2020 IRM Application

EB-2019-0050

Applicant's Responses to OEB Staff Questions

Ref: 2020 IRM rate generator model, Tab 6.2a (CBR)

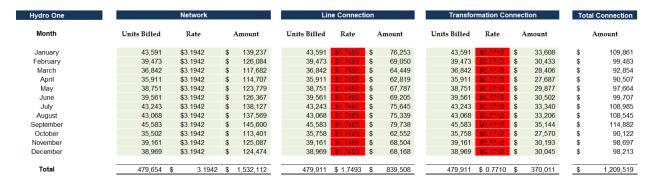
In Tab 6.2a, Lakefront Utilities did not provide data in Cell E19 "total consumption, less WMP" for the 2017 year. However, RRR 2.1.5 shows 235,405,060 kWh for 2017.

- a. Please confirm whether 2017 kWh volumes should be 0 (Cell E19 of Tab 6.2a) boxed above, when RRR 2.1.5 shows 235,405,060 kWh. Please update the rate generator model accordingly.
- b. If Tab 6.2a should include 2016 kWh volumes based on your response to Question-1 c) above, please provide the volume data and confirm that the 2016 volumes entered into the green shaded cells are consistent with RRR filings.

- a) Lakefront confirms that the 2017 kWh volume should be 235,405,060 kWh and Tab 6.2a in the rate generator model has been updated.
- b) Tab 6.2a should include 2016 kWh volumes and Lakefront has updated Tab 6.2a and confirms that the volumes entered are consistent with RRR filings.

EB-2011-0250, Decision and Order, Proposed Settlement Agreement, p. 43 of 104

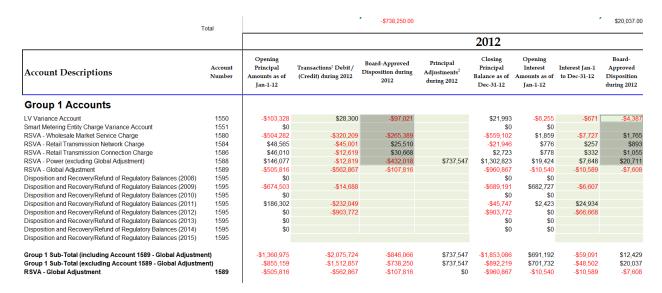
Lakefront Utilities is seeking to dispose of its residual debit balance of \$99,264 from the 1595 (2012) account balance. As noted in the application, Lakefront Utilities seeks to dispose of this residual balance in 1595 (2013) as the IRM rate generator model did not include the applicable line for 2012.

Although the residual balance is within +/-10% of the approved balances for disposition, OEB staff seeks clarification on the accuracy of the principal amounts included in the 1595 (2012) workform.

- a. Please confirm whether there were explicit approvals in the 2012 COS Settlement Agreement (EB-2011-0250) on the principal and carrying charges by account. If yes, please provide the specific reference and list the approvals by account.
- b. For the principal and interest balances entered into 1595 (2012):
 - Please confirm accuracy of the approved amounts entered into the 1595 (2012) workform.
 - ii. Please reconcile the approved balances in the 1595 (2012) workform to what was approved by account.

a) Lakefront Utilities referenced "Lakefront_SettlementProposal_20120426" – specifically page 44.

b) Lakefront confirms that the amounts entered into 1595 (2012) workform are correct.

The total disposed of \$1,206,165 and breakdown between Group 1 and Group 2 of \$1,090,741 and account 1589 of \$115,424 agrees to the table provided in the Settlement Proposal for EB-2011-0250. Further, Lakefront confirms that the total principal of \$1,148,772 and interest of \$57,393 agrees to the General Ledger entry to record the disposition.
